RESPONSE TO REQUEST FOR ADDITIONAL INFORMATION

APR1400 Design Certification

Docket No. 52-046

RAI No.:	**116-8054**
SRP Section:	**14.03.08 – Radiation Protection Inspections, Tests, Analyses, and Acceptance Criteria**
Application Section:	**Tier 1, Various Sections**
Date of RAI Issue:	**07/27/2015**

Figure 2.7.2.5-1 Equipment and Floor Drainage System

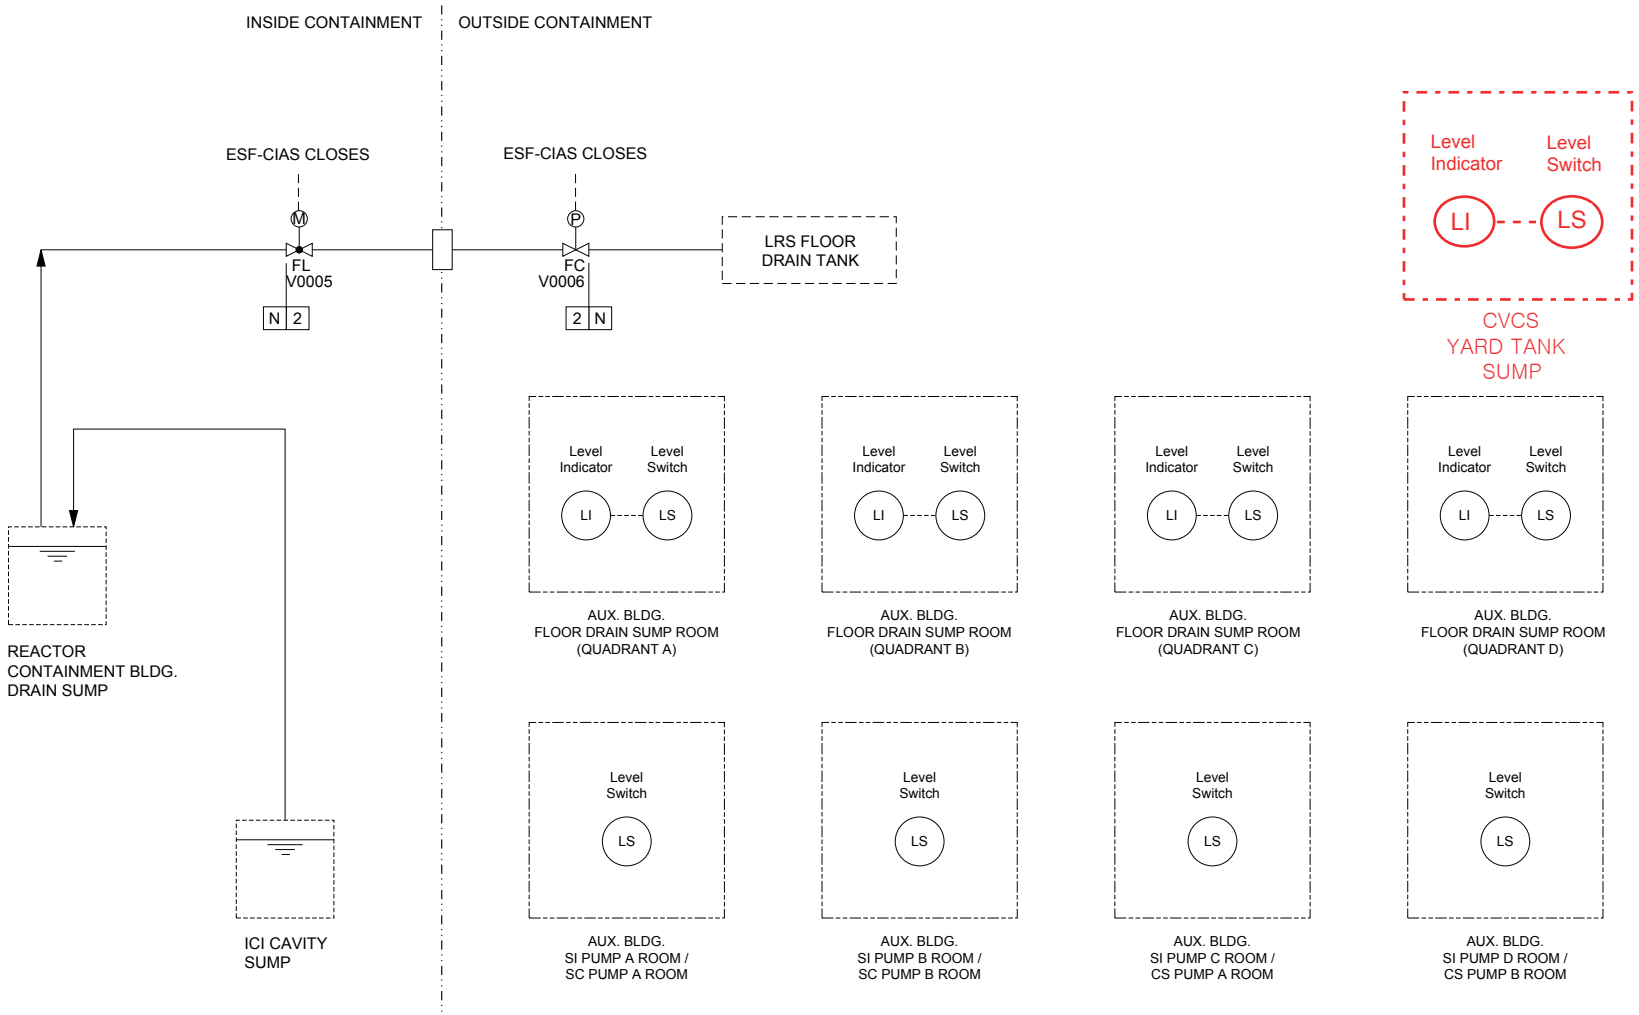
In reviewing Tier 1 ITAAC, staff could not find any ITAAC for design features to minimize contamination. In accordance with 10 CFR 20.1406(b), please provide ITAAC for significant design features to address leaks from high specific activity fluids (such as Reactor

CVCS is designed to comply with 10 CFR 20.1406 as discussed in DCD Tier 2 Subsection 9.3.4.2.10. The holdup tank, boric acid storage tank (BAST), and reactor makeup water tank (RMWT) are located outside in a tank house which is designed with a sloped floor coated with epoxy to facilitate draining and cleaning. The tank house is equipped with a sump that contains level switches to detect leakage and overflow. This leak detection design feature is considered significant and additional ITAAC will be added to DCD Tier 1 Subsection 2.7.2.5 Table 2.7.2.5-4 as presented in Table 3 below.

CVCS yard tanks

9. Leak detection design for the tank house sump for holdup tank, BAST and RMWT provides an alarm in MCR of liquid detection.

9. Leak detection design for the tank house sump for holdup tank, BAST and RMWT provides an alarm in MCR of liquid detection.	9. Inspection of the as-built leak detection system and signal test is conducted to verify the alarm in the MCR.	9. A report concludes that the as-built leak detection is installed as designed; and concludes that the alarm is consistent with the setpoint.
